Access Compliance Report

Public Rights-of-Way

(Curb Ramps)

| Intersection ID: 7375 | Main Street: TRYON ST | Cross Street: TOM HUNTER RD | Location: NW |

| ADA ID: 8AD2F19A49B8 | Ramp Type: BlendTrans1 | Initial Pass/Fail: Pass | Overall Compliance: No |

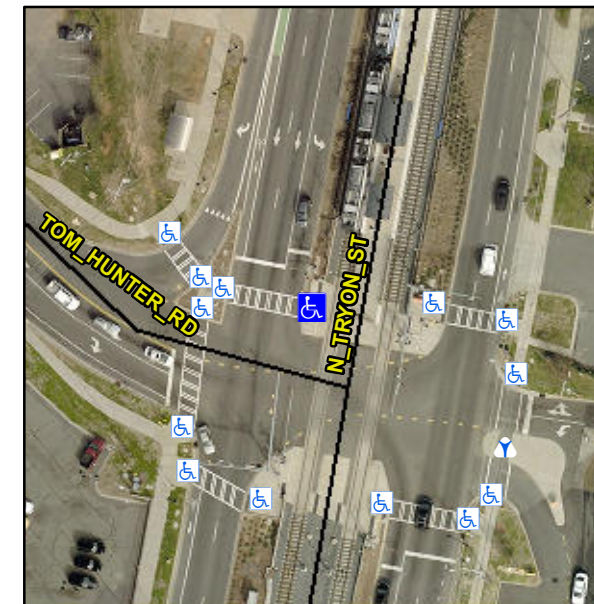
Remove & Replace Curb Ramp With Two New Directional Ramps or Equivalent.

R304.2.1, R304.2.2-Perp, R304.3.2-Para, R304.5.3, R305.2

| Compliance | Description | Data | Compliance | Description | Data |
|------------|-----------------------|-------|------------|-----------------------------|------|
| No | Landing Length (in) | N/A | Yes | DWS Provided? | Yes |
| No | Landing Width (in) | N/A | Yes | DWS Contrast? | Yes |
| No | Landing Slope (%) | N/A | Yes | DWS Length (in) | 24.0 |
| No | Landing X Slope (%) | N/A | Yes | DWS Full Width? | Yes |
| N/A | Landing Curb? (Y/N) | No | No | DWS Offset (in) | 3.5 |
